**REQUEST** Current Zoning: I-2(CD) (general industrial, conditional)  
Proposed Zoning: I-2(CD) SPA (general industrial, conditional, site plan amendment)

**SUMMARY OF PETITION** The petition proposes to amend an approved conditional plan to revise the orientation and layout of a proposed building located in an existing industrial business park, and to eliminate a buffer due to a change in the zoning classification of an adjacent parcel of land.

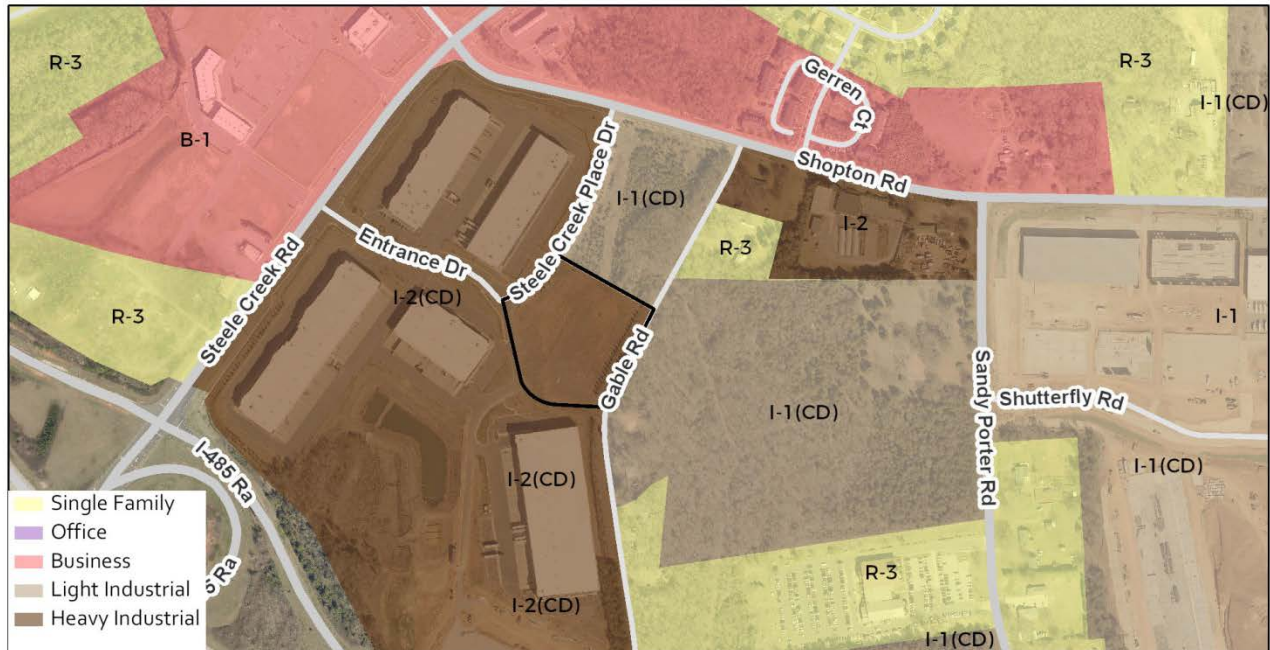
- ~~1. Note 2.B. should reflect the allowed square footage for the subject 3.96 acres and not the entire 36 acres originally rezoned. Addressed.~~
  - ~~2. An administrative amendment that reflects the reduction in the square footage for this property must be submitted prior to this petition being placed on the Zoning Committee Work Session agenda. Addressed.~~
-
